**PRODUCT SERVICE ADVISORY**

**Logix Platforms**

Ref: ACIG 2007-05-002

### Manual Inspection of a Product in Operation

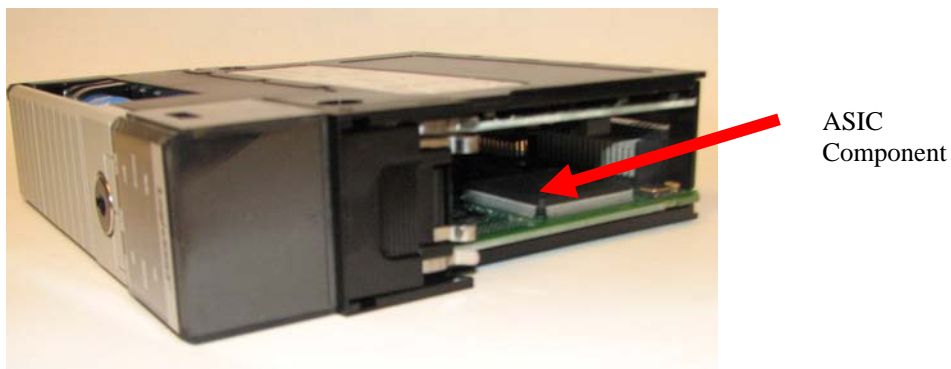
2. Inspect the Logix product and locate the component as shown below. It will always be next to the backplane connector.

3. If the ASIC bears the name Atmel as shown in the photo below, your Logix product may be affected by the issue described above. Two additional checks must be done to verify if this issue applies to your module. If the serial number does not end in the number 64, as indicated in the red circle, or if there is a white or silver dot in the upper left corner, this PSA does not apply. If you verify the PSA does apply to your module see the section “Required Customer Action” for information on how to exchange your Logix product for a new one.
